**AGENDA  
CITY OF ST. CHARLES  
PLANNING & DEVELOPMENT COMMITTEE  
ALD. CLIFF CARRIGNAN – CHAIRMAN**

Title:	Recommendation to approve a Map Amendment, Preliminary Subdivision Plan and Final Plat of Subdivision (Delnor Woods Subdivision)
--------	--

**RE:** Delnor Woods Subdivision

The following are outstanding comments on the plan submittal of January 15, 2013, in addition to review comments from Development Engineering:

### LANDSCAPE PLAN

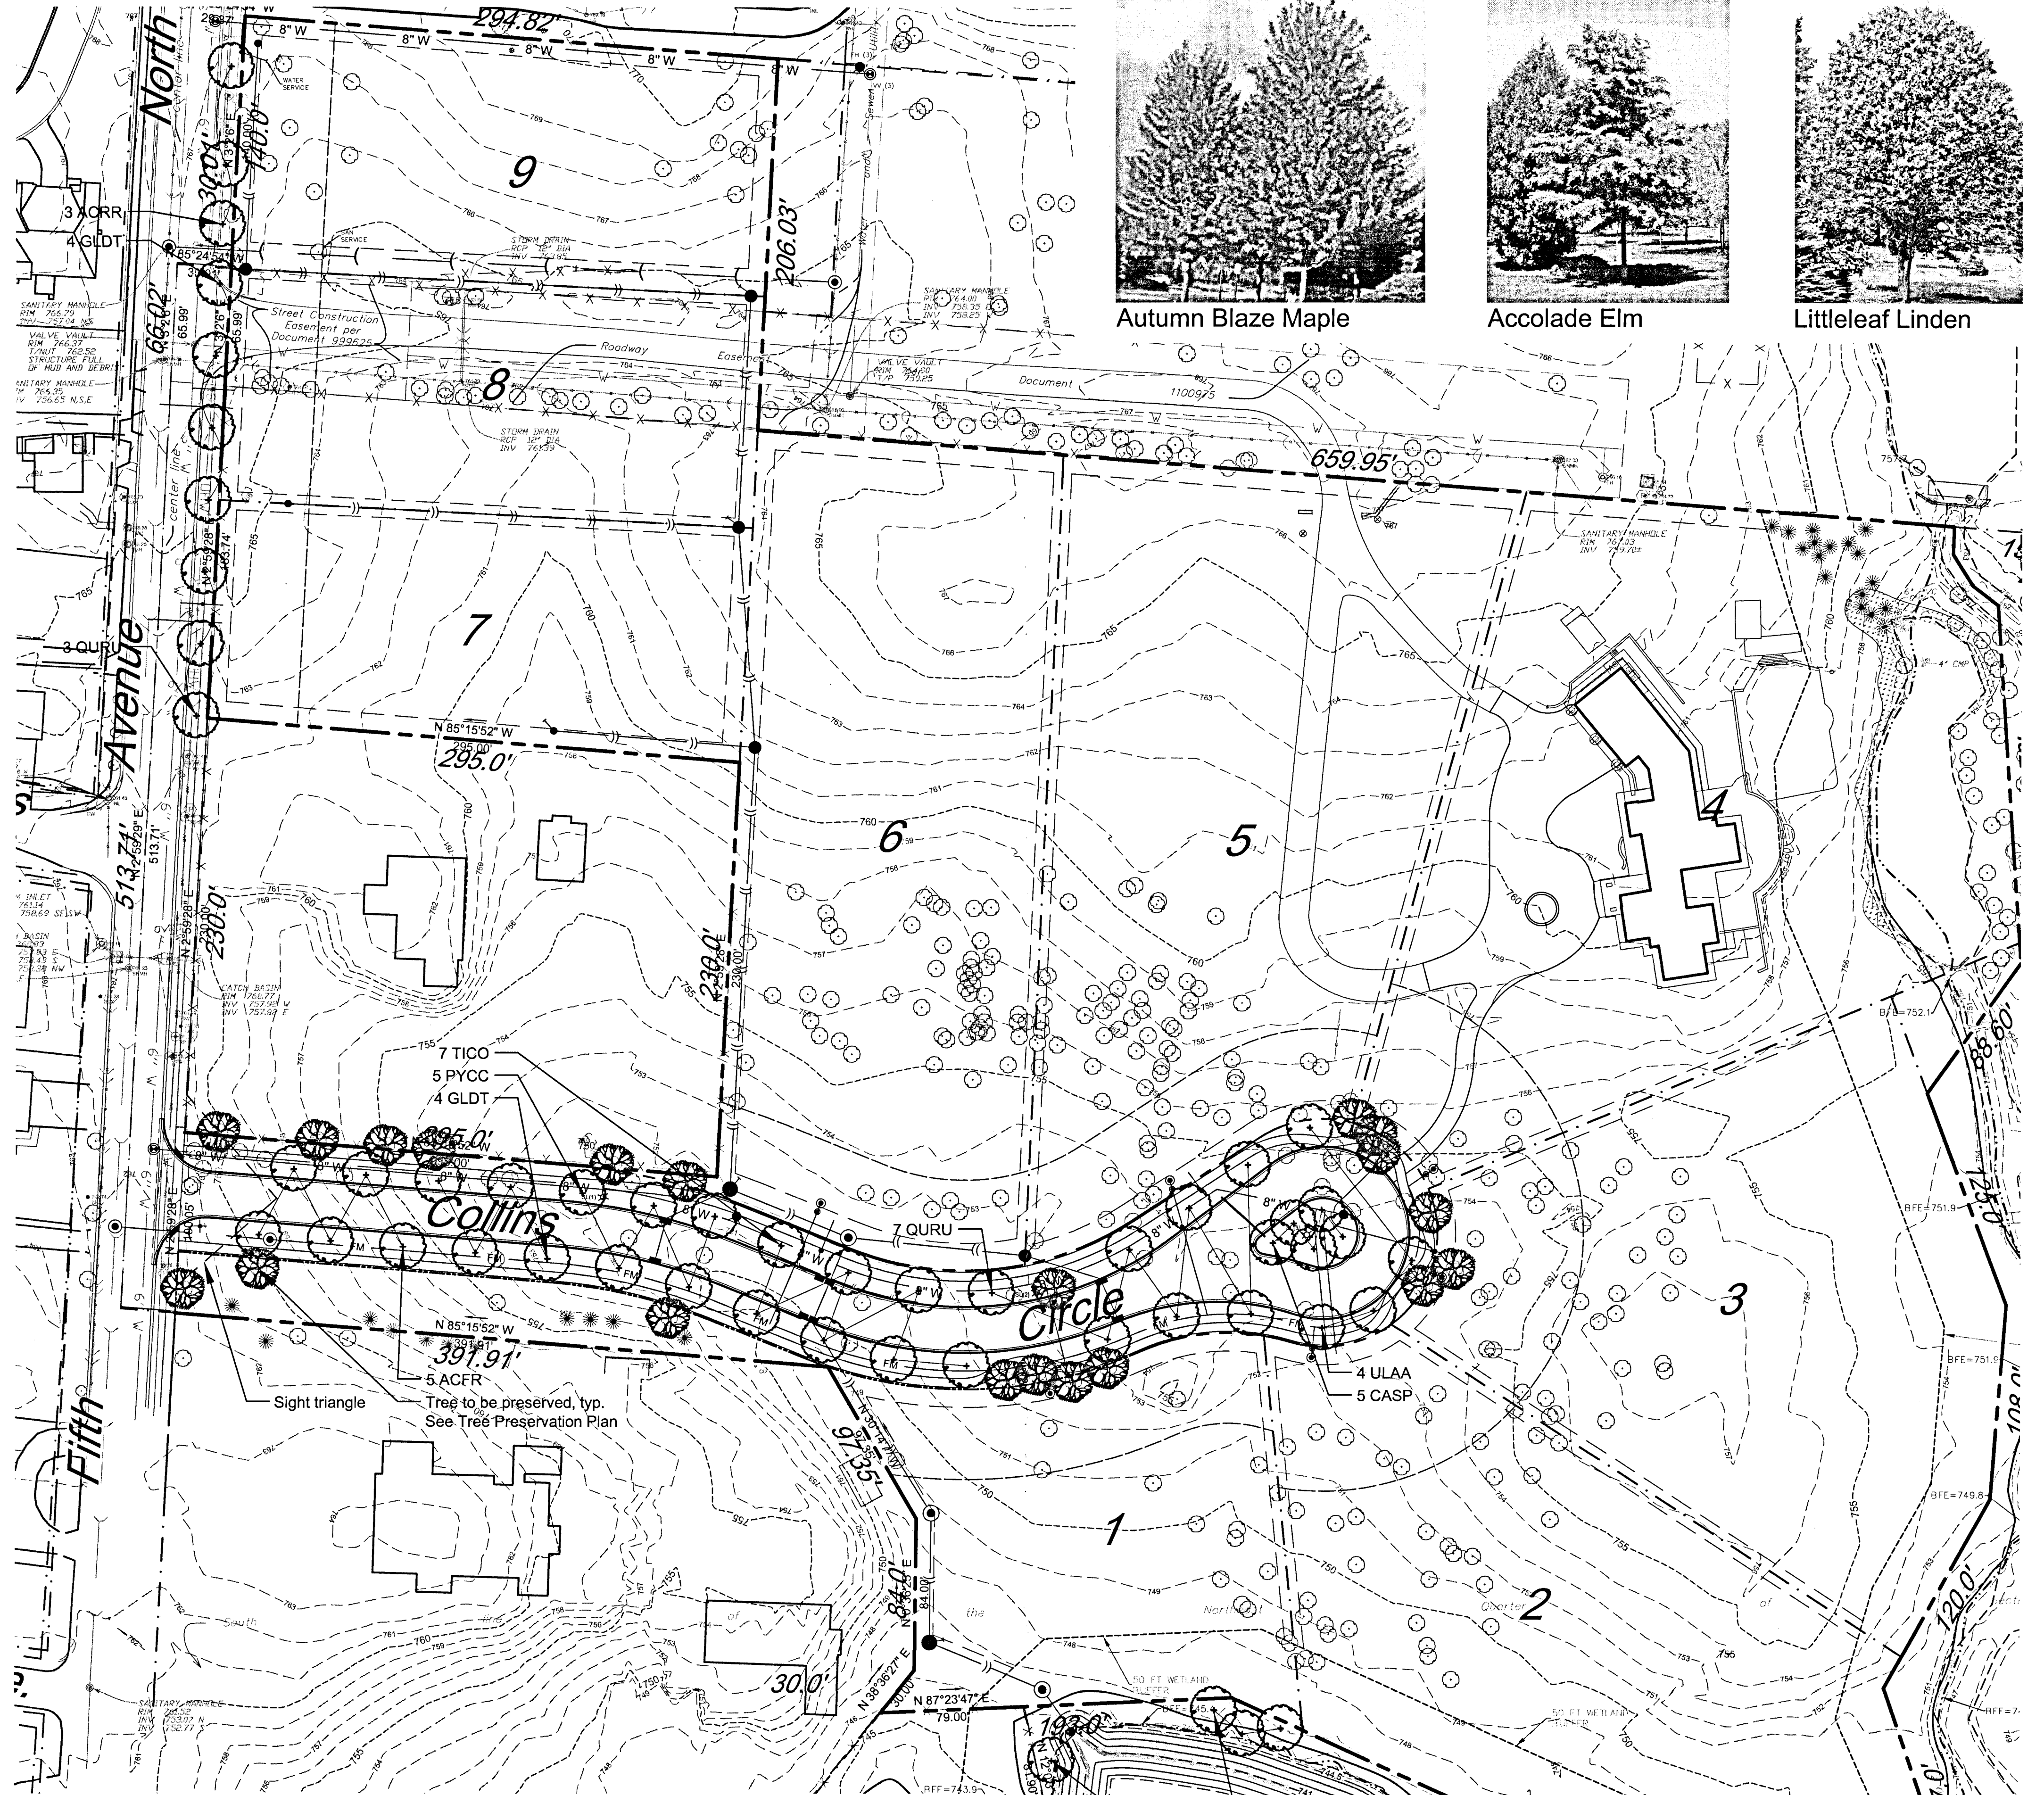
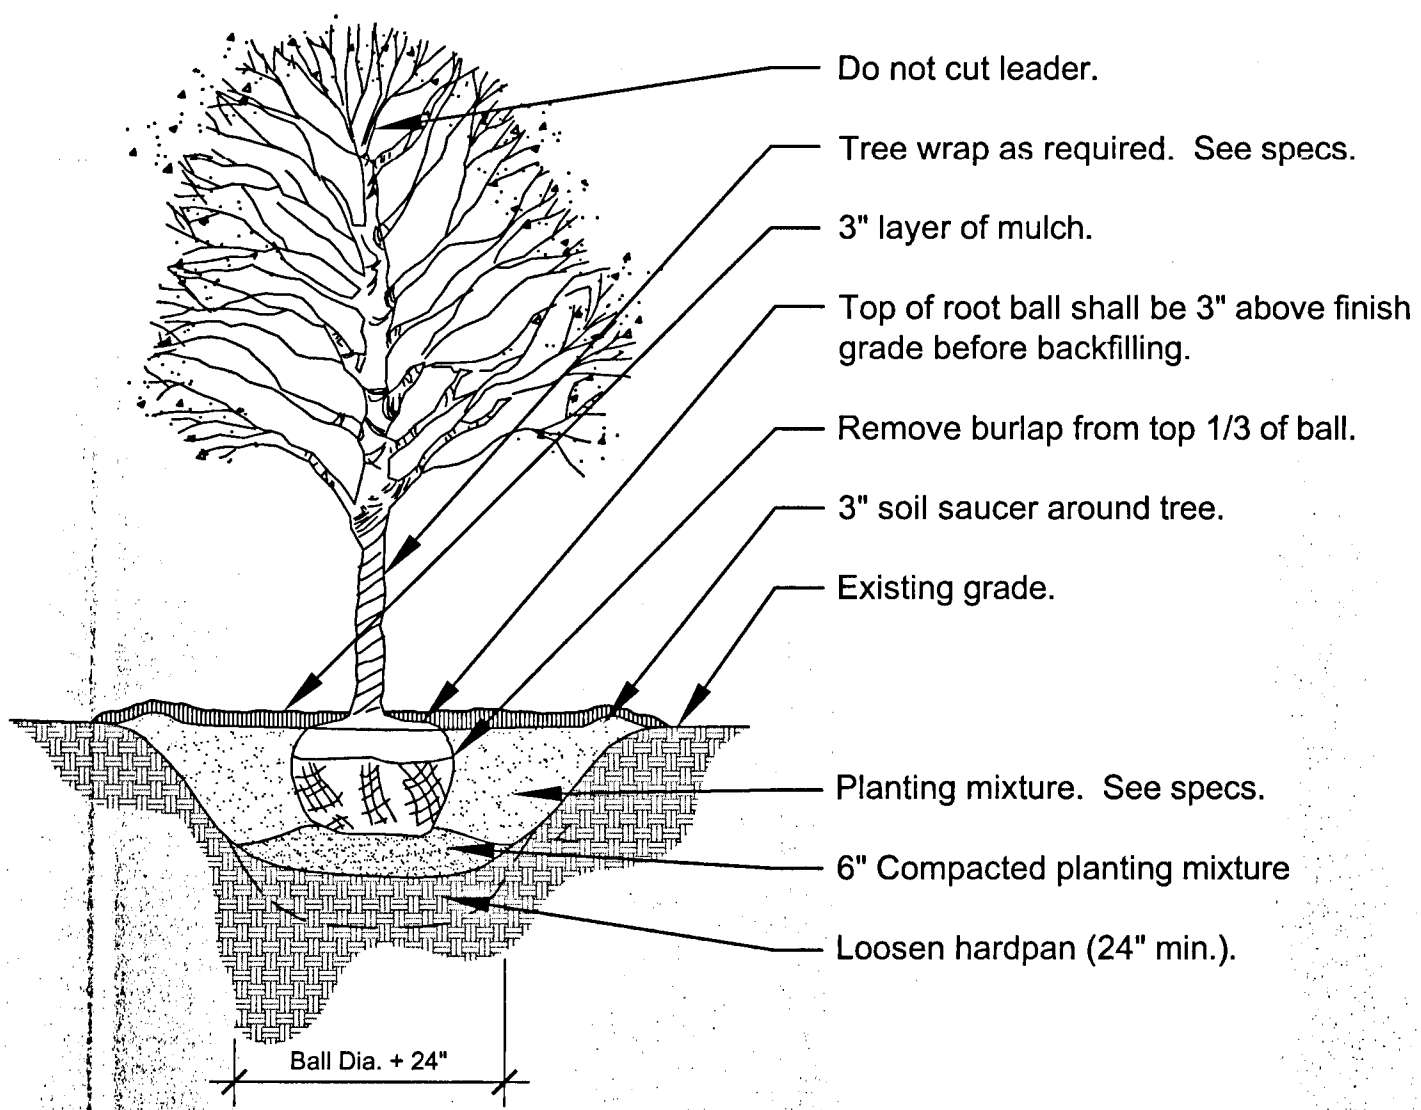
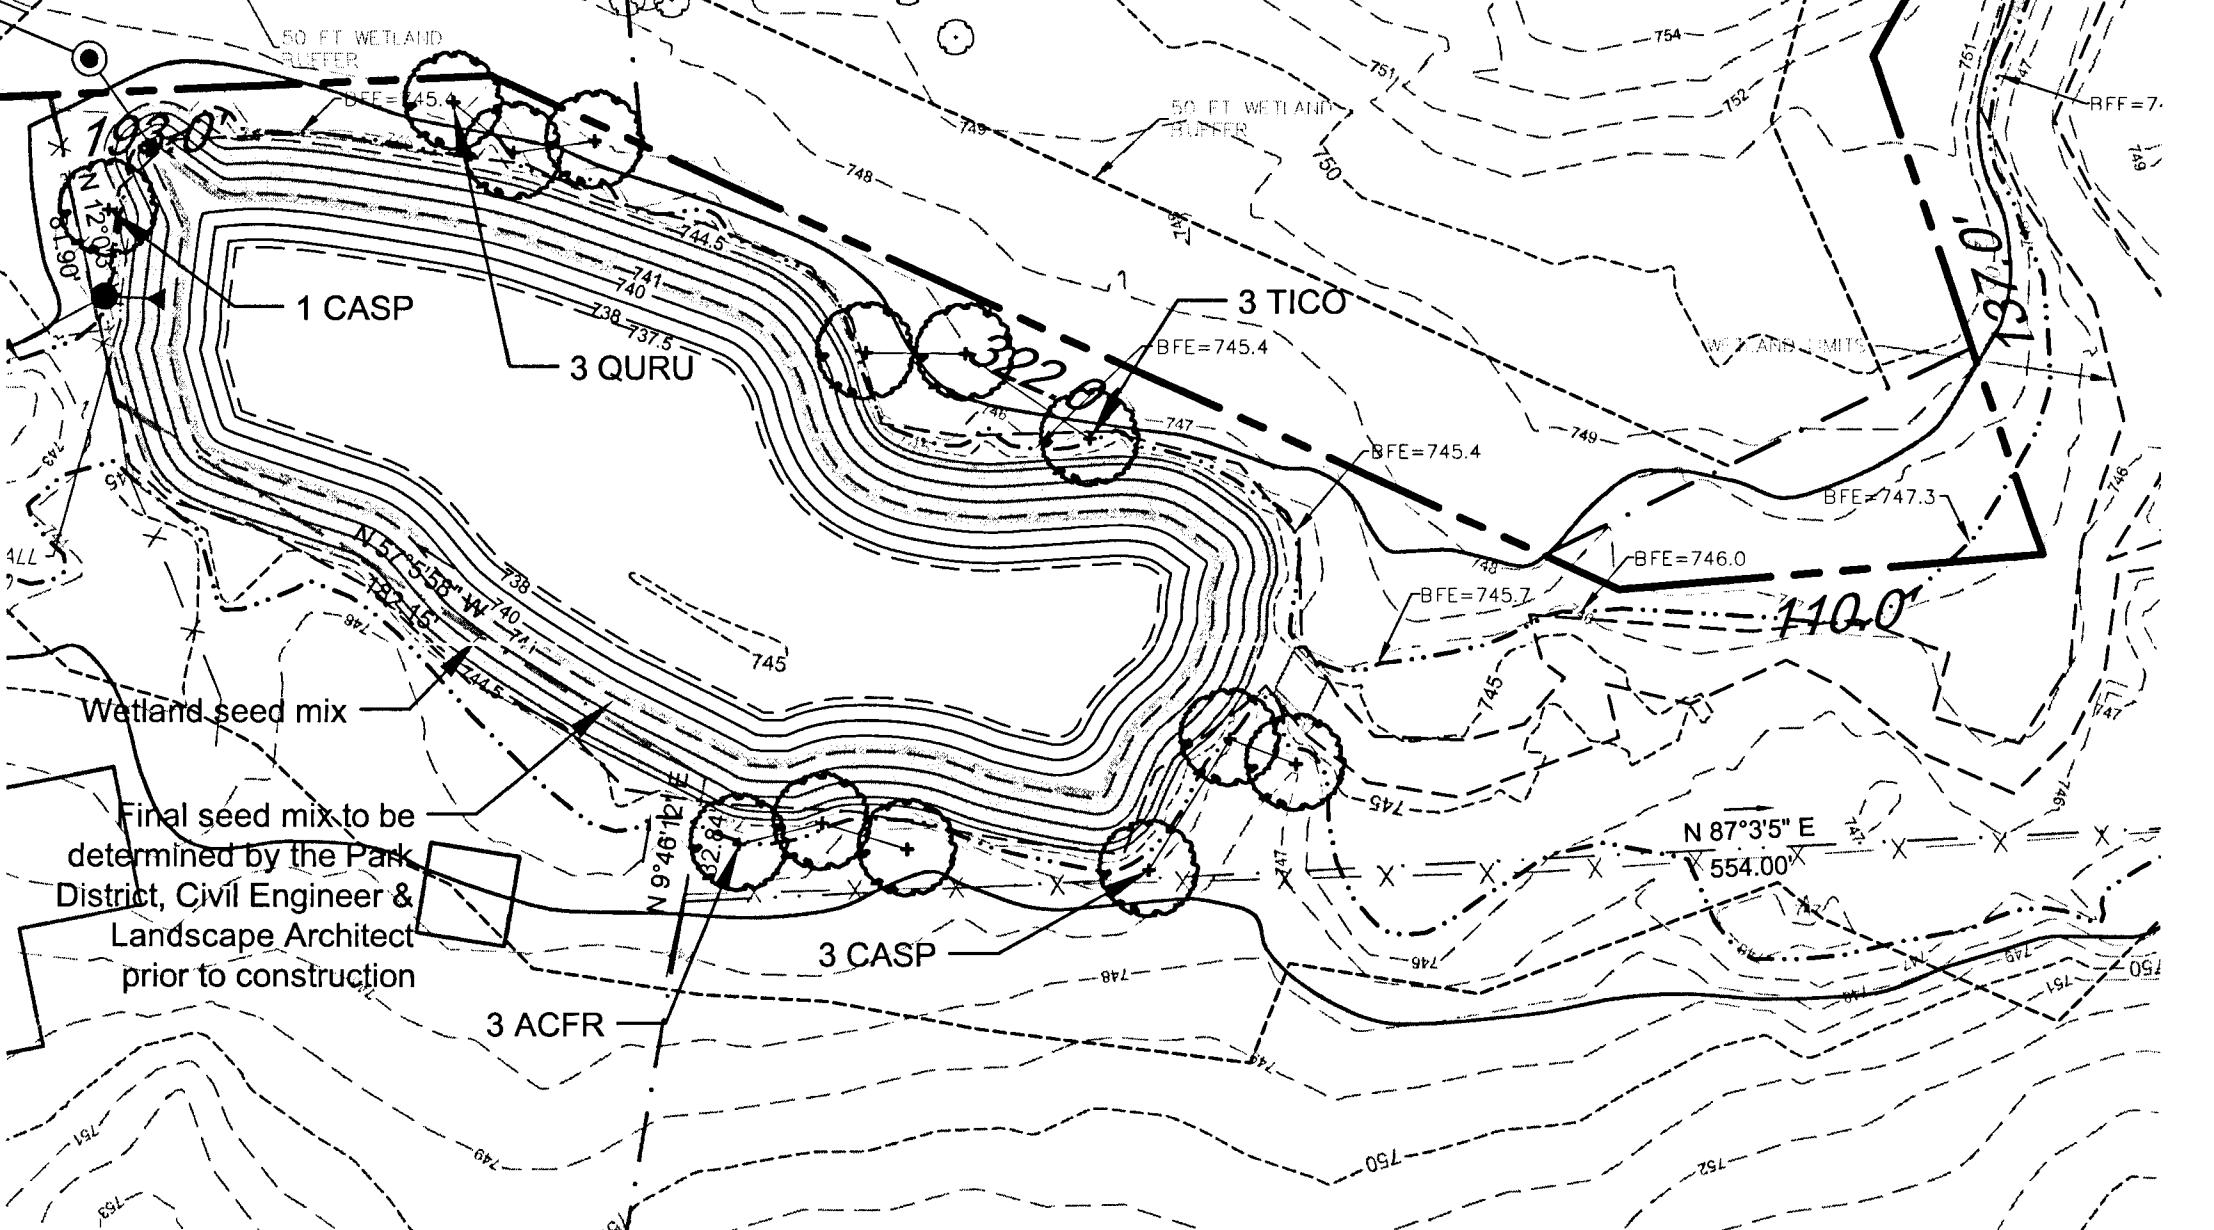
15. There are numerous areas that do not comply with City codes regarding separation. These need to be corrected prior to landscape plan approval.
16. The tree variety is currently being reviewed by the City Arborist and any comments relating to this will be forwarded when available.
17. Has the developer given any thought to entering into a Tree Agreement with the City of St. Charles?

29. Plan and profile shows an average depth of the proposed force main to be 3.5ft. The landscape plan shows deciduous tree plantings directly over the force main. The depth of these plantings including hardpan preparation will be in conflict with the force main. Force main shall be relocated within the roadway limits.
